UNITED STATES
NUCLEAR REGULATORY COMMISSION
WASHINGTON, D. C. 20555

ENCLOSURE 2

SAFETY EVALUATION OF THE REQUEST TO OPERATE
THE SHOREHAM NUCLEAR POWER STATION AT 25% POWER
ACCIDENT EVALUATION

Figure 1 Accident signatures for the MSIV-closure ATWS from 100% power operation, first 45 minutes with no operator action

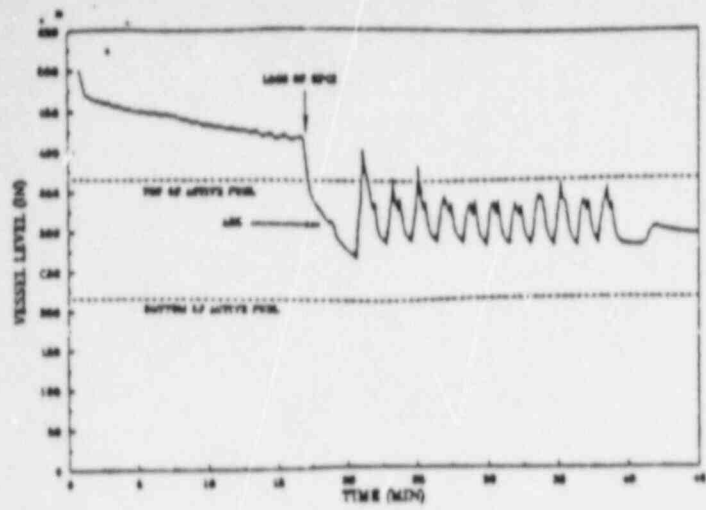
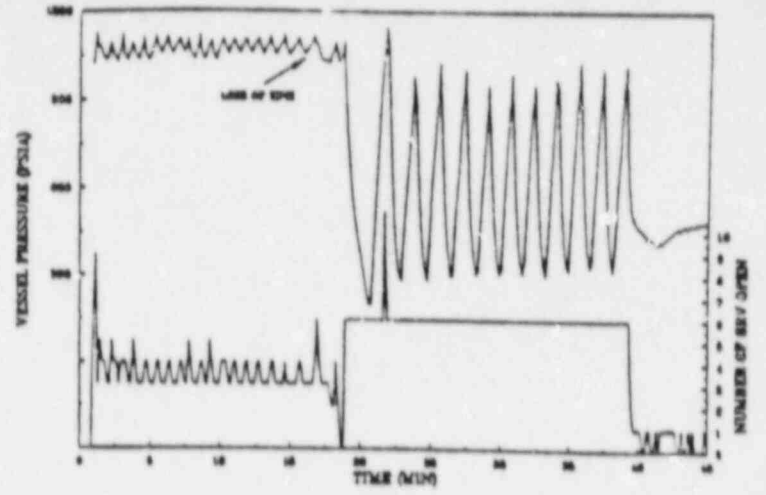
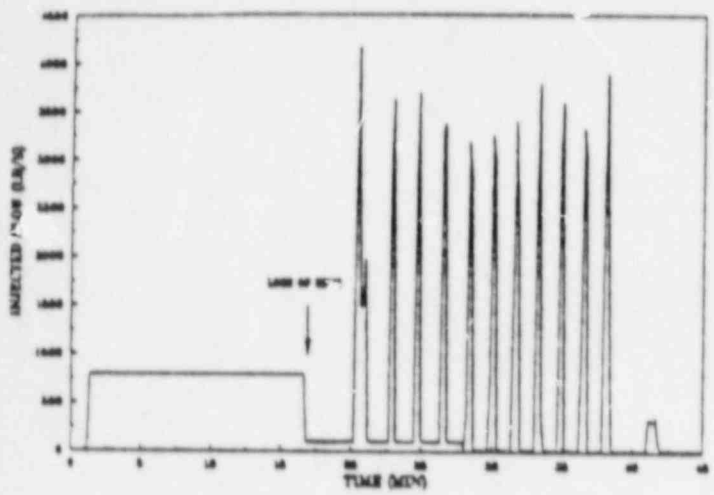
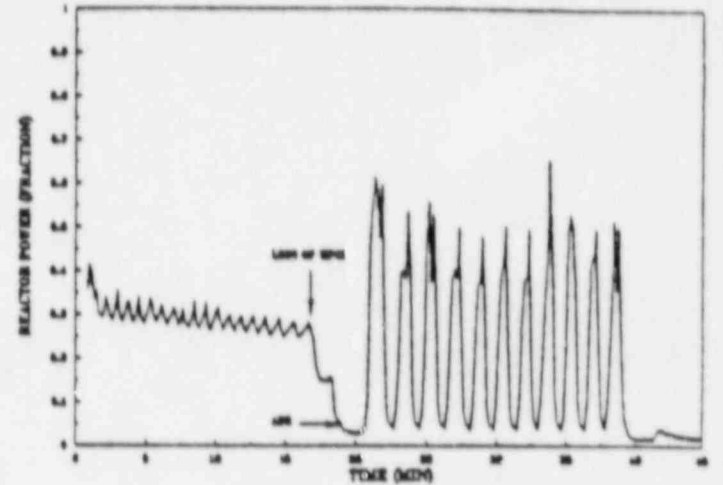
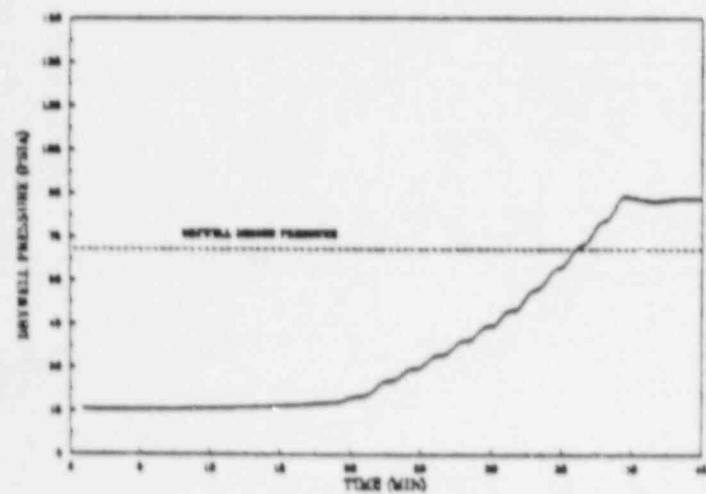
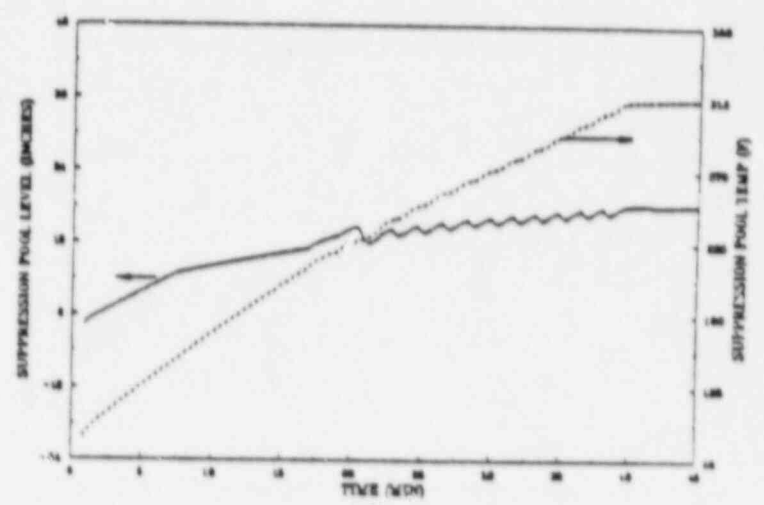
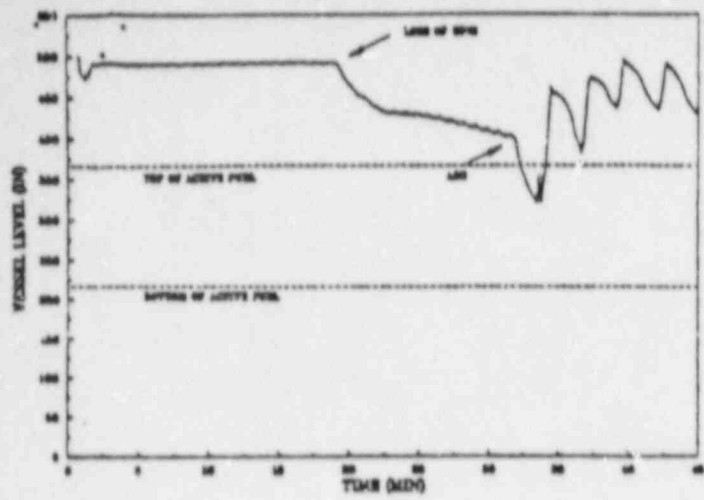
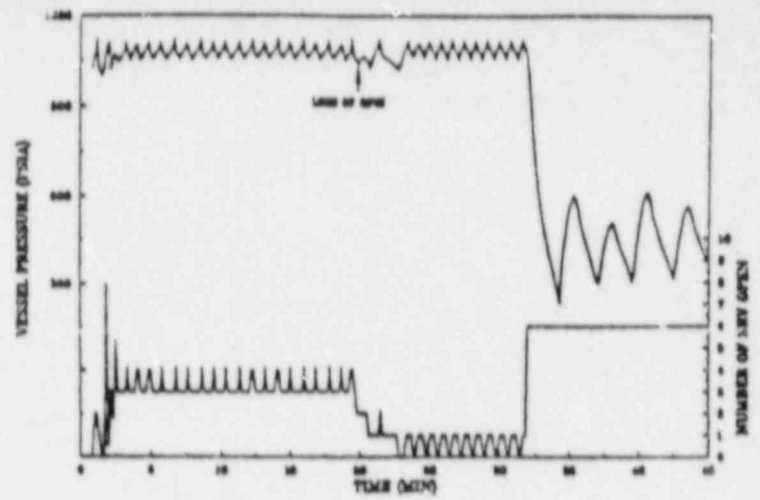
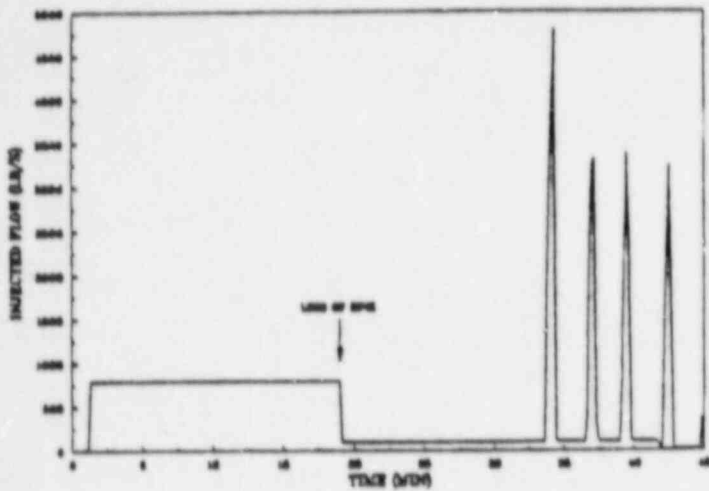
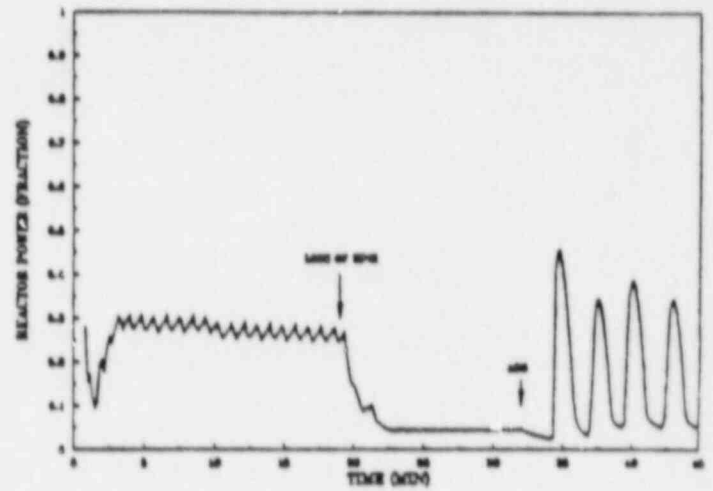
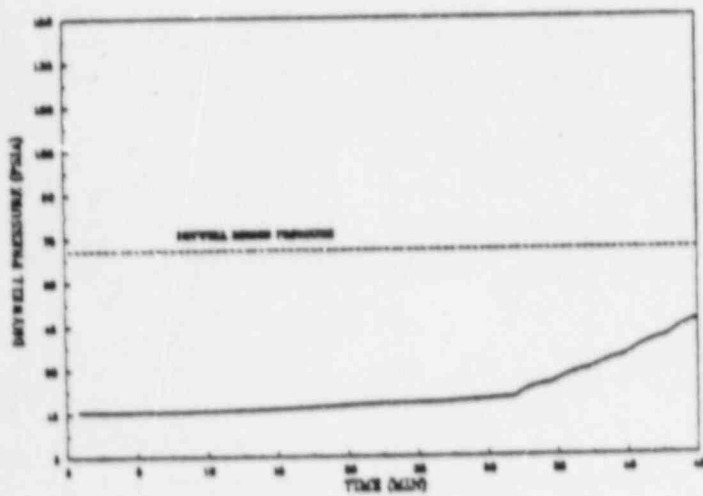
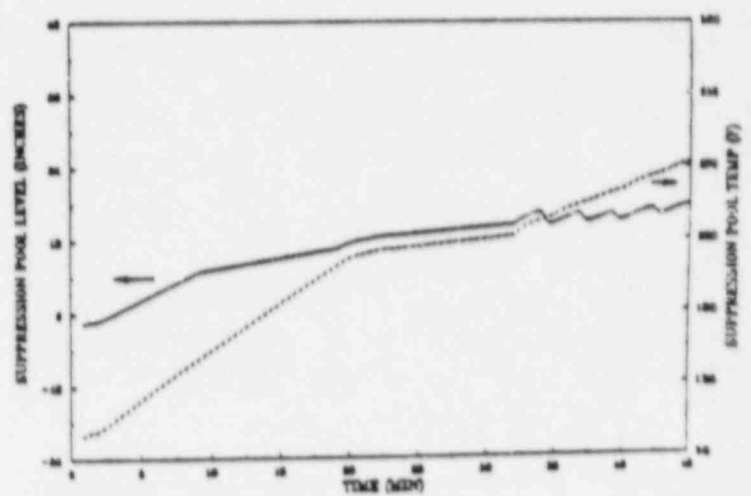
The calculated results for the two cases are shown in Figures 1 and 2. In the analyses, HPCI, RCIC, and CRD injection maintain reactor vessel water level above the top of core until failure (by assumption) of the HPCI turbine at a suppression pool temperature of 210°F. With HPCI system failure, reactor vessel water level decreases, leading to ADS actuation. As the vessel is depressurized into the regime in which the low pressure injection systems are able to pump cold water into the vessel, oscillations in injection flow, core power, and vessel pressure occur as a result of positive reactivity insertion associated with collapse of voids in the core by cold water. Similar trends are observed in both cases but the following key differences should be noted:

1. The time to ADS actuation and core uncover is significantly later for 25 percent power,
2. The frequency and magnitude of pressure and power oscillations is reduced for 25 percent power, and
3. Drywell pressure remains below the design value for 25 percent power but exceeds it for 100 percent power.

Much of these differences in behavior can be attributed to the fact that the negative reactivity of the core voids relative to that of the control blades is less with the control blades in their 25 percent power configuration. It follows that perturbations that tend to collapse voids in the core region will insert less positive reactivity with the control blades in their 25 percent power positions than with the control blades in their 100 percent power positions. Hence, the core response to positive reactivity insertions caused by uncontrolled cold water injection by the low pressure ECC systems is more sluggish at 25 percent power.

On the basis of these calculations, the staff concludes that adequate mitigation of an ATWS accident sequence, given failure of complete shutdown, is much simpler for the control room operators if the control blades are in their configuration for 25 percent power operation as opposed to their configuration at 100 percent power. While we expect the likelihood of ATWS events to be extremely low at Shoreham due to hardware improvements and mitigative capabilities at 25 percent power, should an ATWS occur the safety concerns at 25 percent power would be substantially less than at full power.

Figure 3 CRAC2 calculated dose-versus-distance probability distributions for whole body dose of 5 rem -- wetwell venting scenario

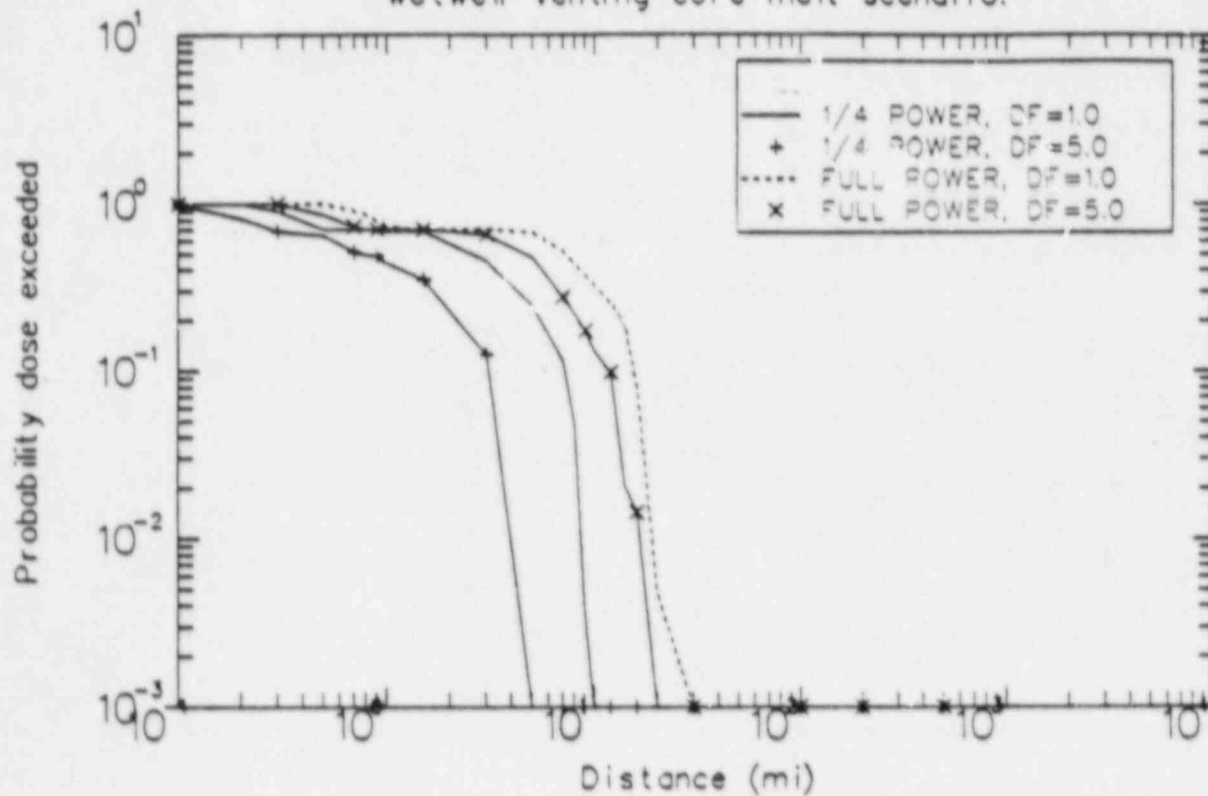
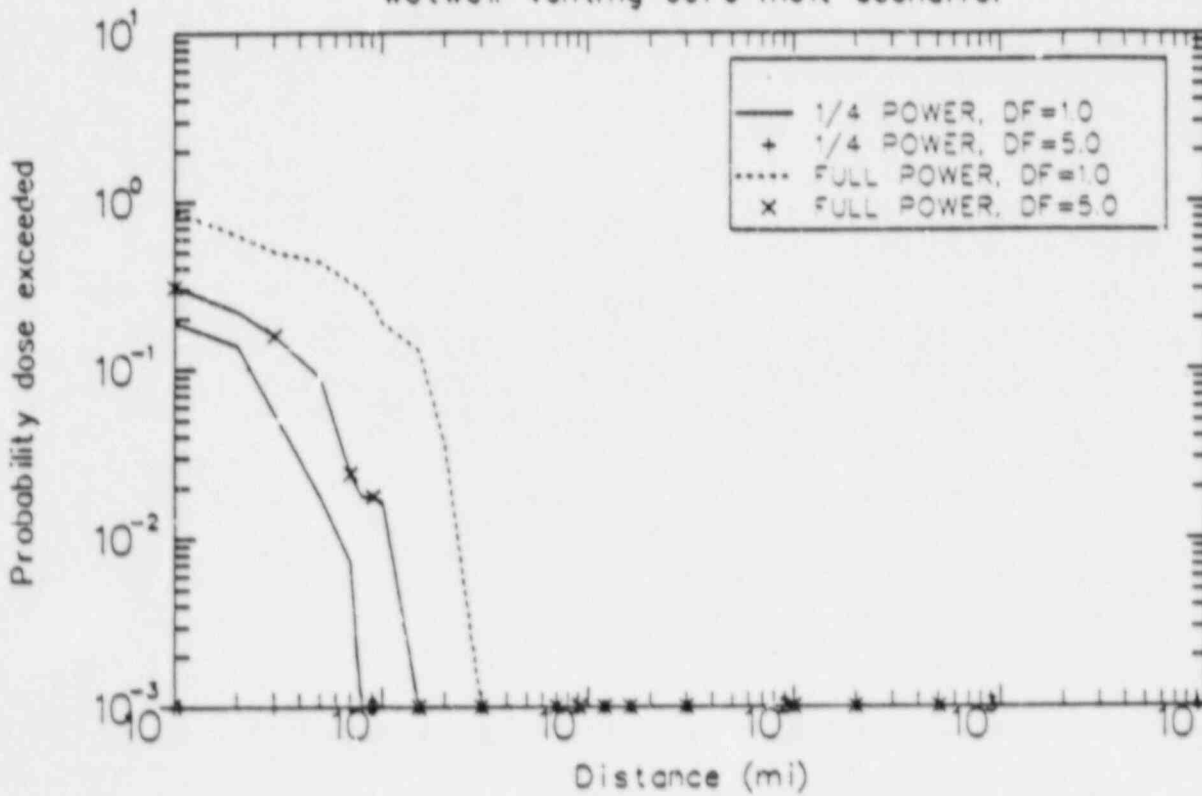
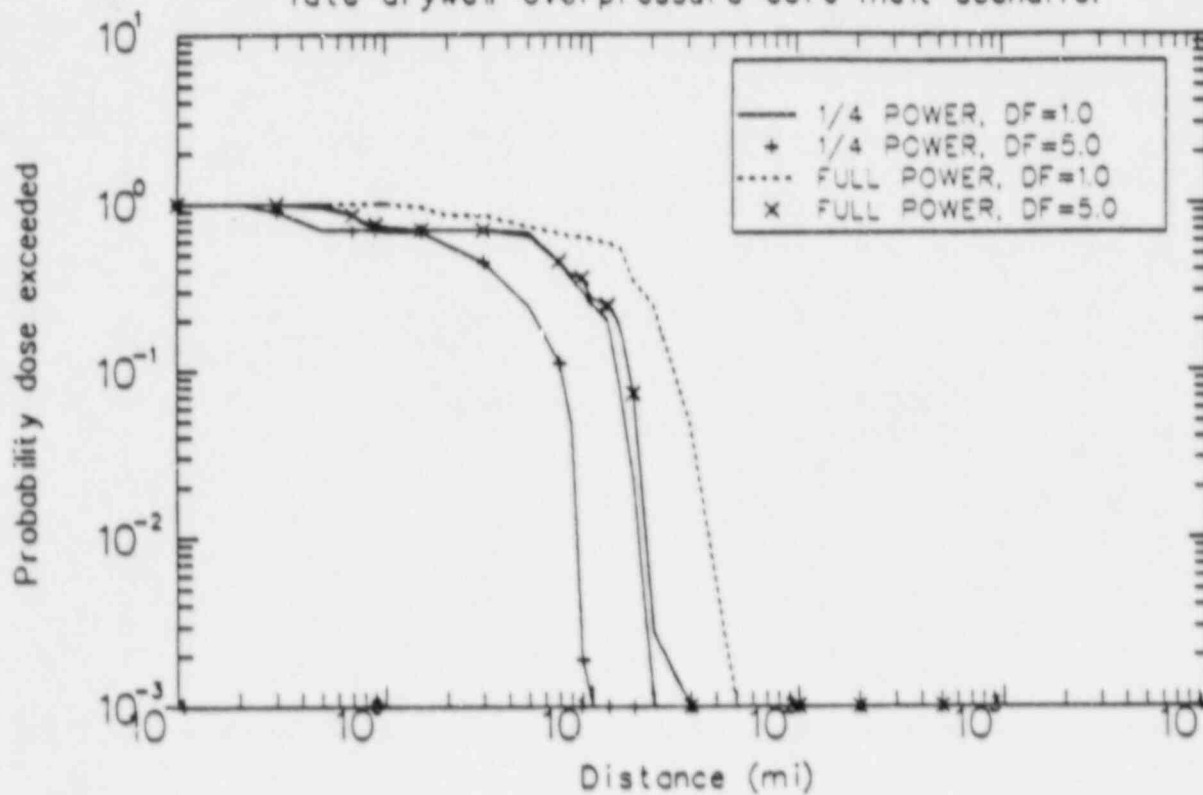
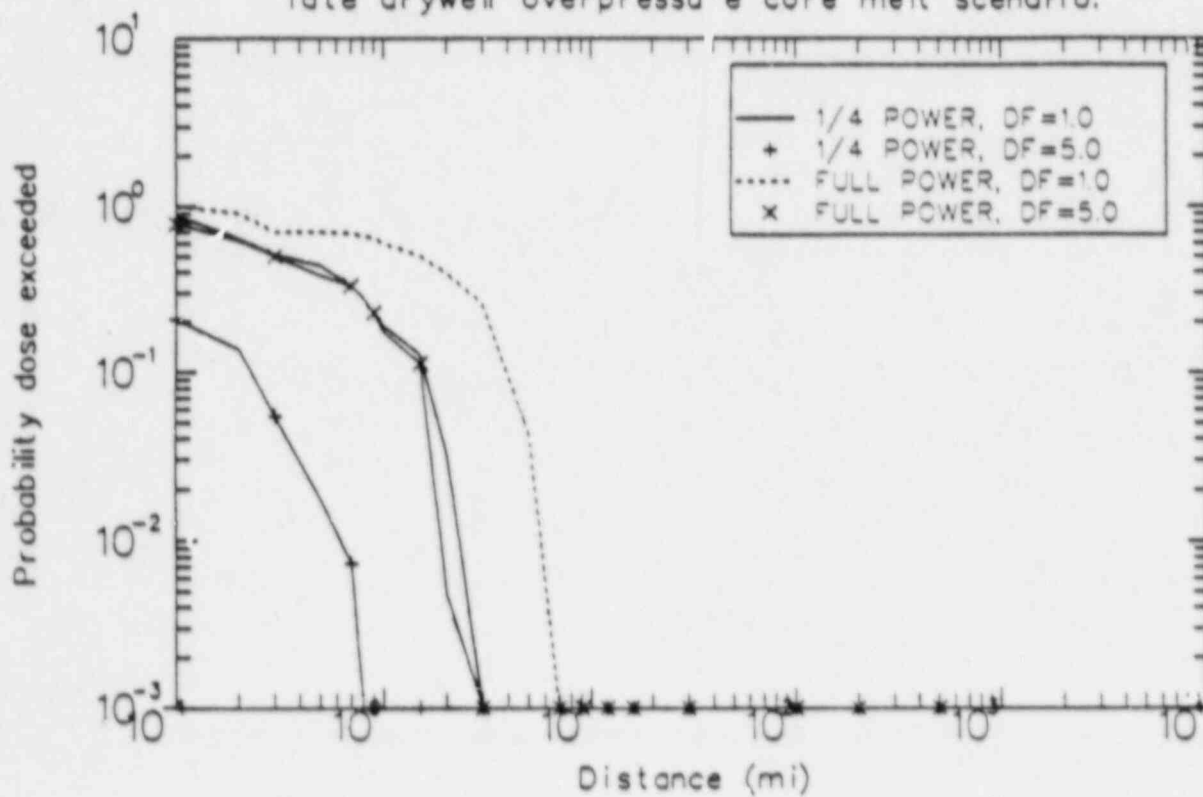
Figures 3 and 4 show the five rem and 200 rem whole-body dose-versus-distance results for the core melt scenario with wetwell venting. Similar results are shown in Figures 5 and 6 for the scenario with drywell overpressure failure. Unlike the final results presented in the utility submittal (as well as the curves presented in NUREG-0396), the probabilities shown for each scenario are conditional upon that scenario occurring. In contrast, the LILCO leakage categories were weighted by the release category probability given a core melt and the results were summed over all release categories.

The dose-versus-distance curves provide insights regarding the distances from the reactor over which either the Protective Action Guides (PAGs) might be exceeded or injury-threatening doses might occur in the more likely core melt sequences. However, because of the limited nature of this assessment and the large uncertainties inherent in estimation of source terms and modelling of offsite consequences, these results should be interpreted in a qualitative manner, i.e., they should not be used to estimate reduced distances over which protective measures may need to be taken in the event of an accident. Suffice it to say that the distance over which a given dose is exceeded would be significantly reduced at 25 percent power (by a factor of about three relative to full power) but that estimation of the absolute distances at which major reductions occur in the probability of dose exceedance would require a further assessment of uncertainties.
